Service Manual

SL-20-(M)/SL-20A-(M)

Supplementary-2

SUBJECT: Separate motor and the F.G. SERVO P.C.B.

NEW COMPONENT PACKING PROCEDURE
FOR MODELS SL-20 AND SL-23.

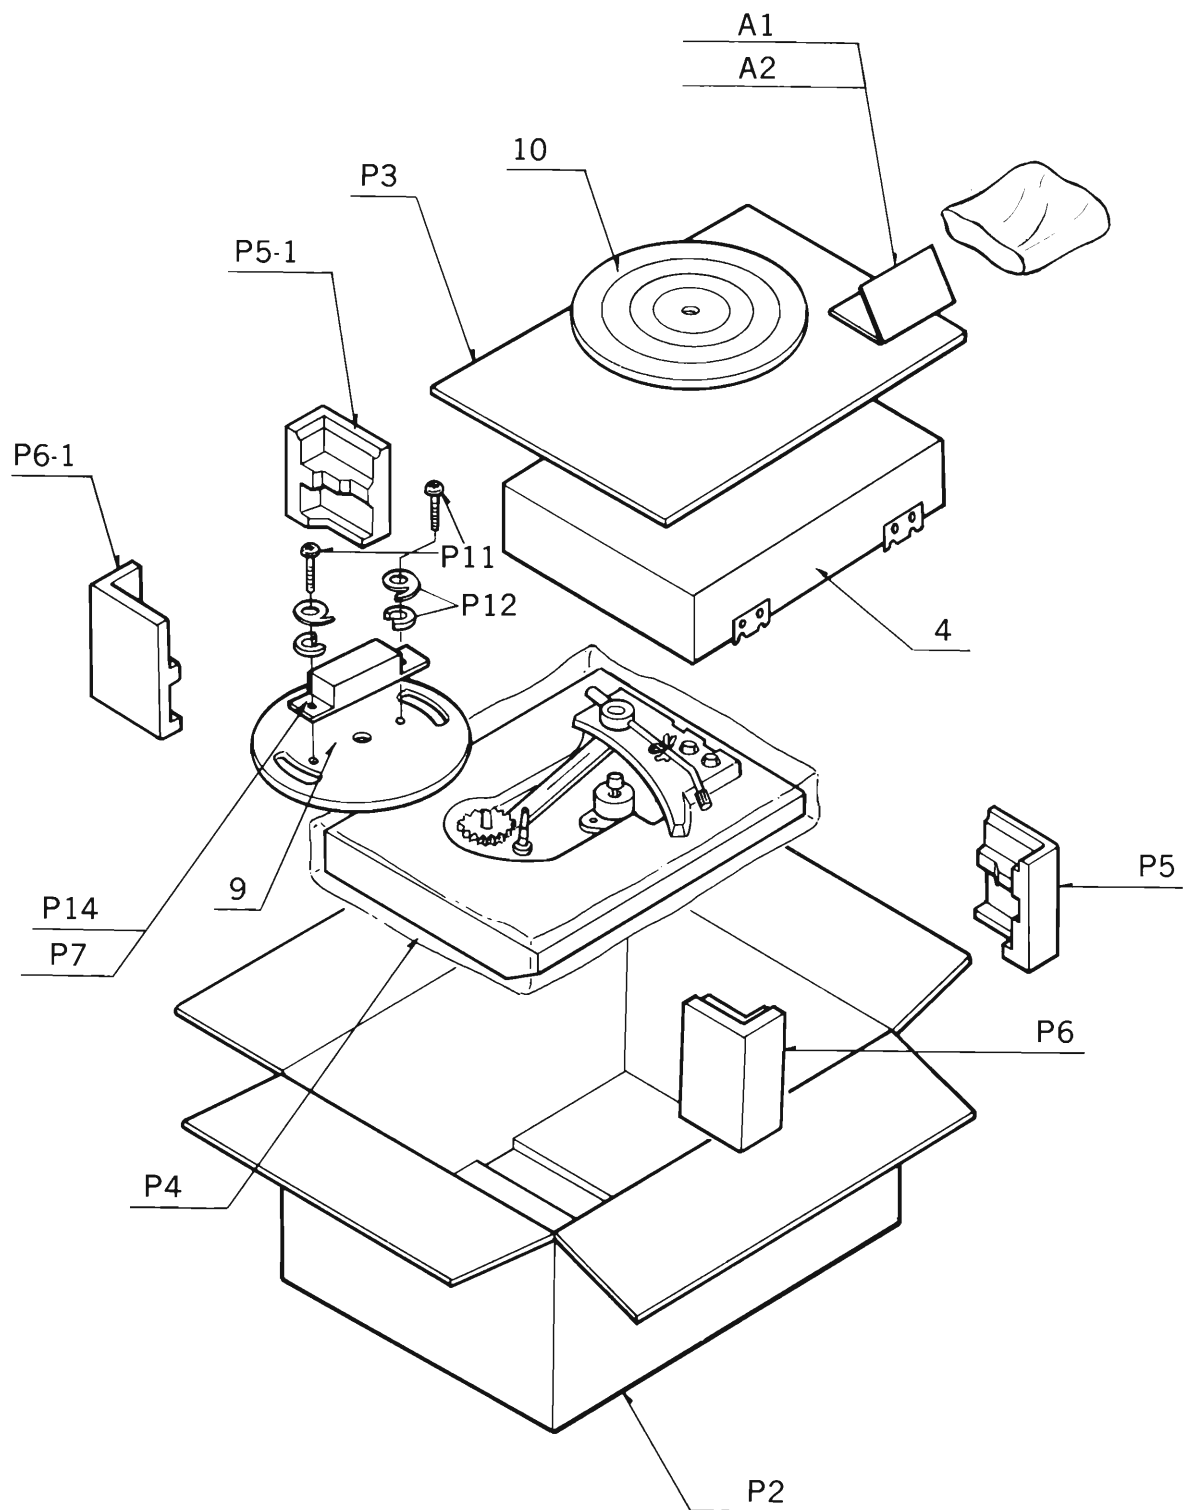
Subject: Packing materials and Turntable mat modification.
Both old and new parts are not interchangeable

Ref.No.	Part No.		Description	Q'TY	Remarks
	OLD	NEW			
P2	SFHP020E01	SFHP020M02	Inside Packing Case	1	SL-20A-(M),SL-20-(M)
P2	SFHP020C01	SFHP020C02	Inside Packing Case	1	SL-20-(MC)
P3	SFHD020L01	SFHD023L02	Upper board	1	SL-20A-(M),SL-20-(M,MC)
P4	SFHZ055-1	SFHZ023L01	Side Pad	1	SL-20A-(M),SL-20-(M,MC)
P5	SFHH020L01	SFHH023L03	Coner Pad (Front Right)	1	SL-20A-(M),SL-20-(M,MC)
P5-1	SFHH020L01	SFHH023L04	Coner Pad (Rear Right)	1	SL-20A-(M),SL-20-(M,MC)
P6	SFHH020L02	SFHH023L01	Coner Pad (Front Left)	1	SL-20A-(M),SL-20-(M,MC)
P6-1	SFHH020L02	SFHH023L02	Coner Pad (Rear Left)	1	SL-20A-(M),SL-20-(M,MC)
P7	SFHD020X01	SFHH023L05	PartS Box	1	SL-20A-(M),SL-20-(M,MC)
P8	SFHH020L03	○	Parts Box	1	SL-20A-(M),SL-20-(M,MC)
P14	●	SFHD023M01	Top lid,Parts Box	1	SL-20A-(M),SL-20-(M,MC)

Ref.No.	Part No.		Description	Q'TY	Remarks
	OLD	NEW			
P2	SFHP023M01	SFHP023M02	Inside Packing Case	1	SL-23A-(M),SL-23-(M)
P2	SFHP023C01	SFHP023M02	Inside Packing Case	1	SL-23-(MC)
P3	SFHD020L01	SFHD023L02	Upper board	1	SL-23A-(M),SL-20-(M,MC)
P4	SFHZ055-01	SFHZ023L01	Side Pad	1	SL-23A-(M),SL-20-(M,MC)
P5	SFHH020L01	SFHH023L03	Coner Pad (Front Right)	1	SL-23A-(M),SL-20-(M,MC)
P5-1	SFHH020L01	SFHH023L04	Coner Pad (Rear Right)	1	SL-23A-(M),SL-20-(M,MC)
P6	SFHH020L02	SFHH023L01	Coner Pad (Front Left)	1	SL-23A-(M),SL-20-(M,MC)
P6-1	SFHH020L02	SFHH023L02	Coner Pad (Rear Left)	1	SL-23A-(M),SL-20-(M,MC)
P7	SFHD020X01	SFHH023L05	Parts Box	1	SL-23A-(M),SL-20-(M,MC)
P8	SFHH020L03	○	Parts Box	1	SL-23A-(M),SL-20-(M,MC)
P14	●	SFHD023M01	Top lid,Parts Box	1	SL-23A-(M),SL-20-(M,MC)

CHECK POINTS

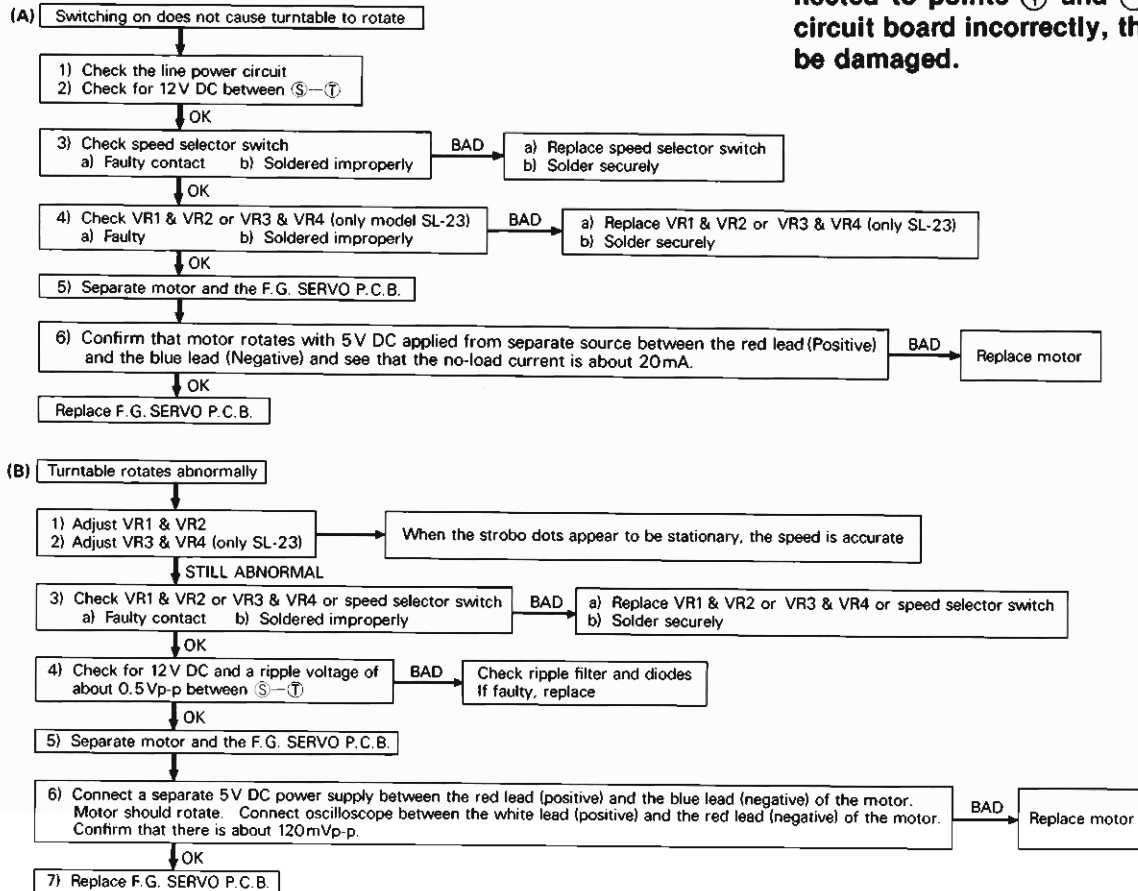
OLD				NEW			
NO.	PART NO.	DESCRIPTION	Q'TY	NO.	PART NO.	DESCRIPTION	Q'TY
7	SFMC020L01E SL-20	Motor ass'y (w/capstan & P.C.B.)	1	VR1, 2	EVN31AA00B24	Variable resistor	2
6	SFMC023L01E SL-23	Motor ass'y (w/capstan & P.C.B.)	1	6-7	SFMH825B01R	Motor (w/capstan)	1
				6-8	FE-EGA462	P.C.B. ass'y	1

CAUTION: If the DC power supply is connected to points $\oplus$ and $\ominus$ on the circuit board incorrectly, the IC will be damaged.

- If you replace the motor or the circuit board (F.G. SERVO P.C.B.), please adjust VR1 and VR2.
When the strobo dots appear to be stationary, the speed is accurate.
- If you adjust VR1 or VR2, please turn first VR3 or VR4 to center position (only SL-23)
- The speed will be too fast, if the strobo dots seem to be "running ahead".
In this case turn the VR1 or VR2 counterclockwise — (SL-20)
In this case turn the VR1 or VR2 clockwise — (SL-23)
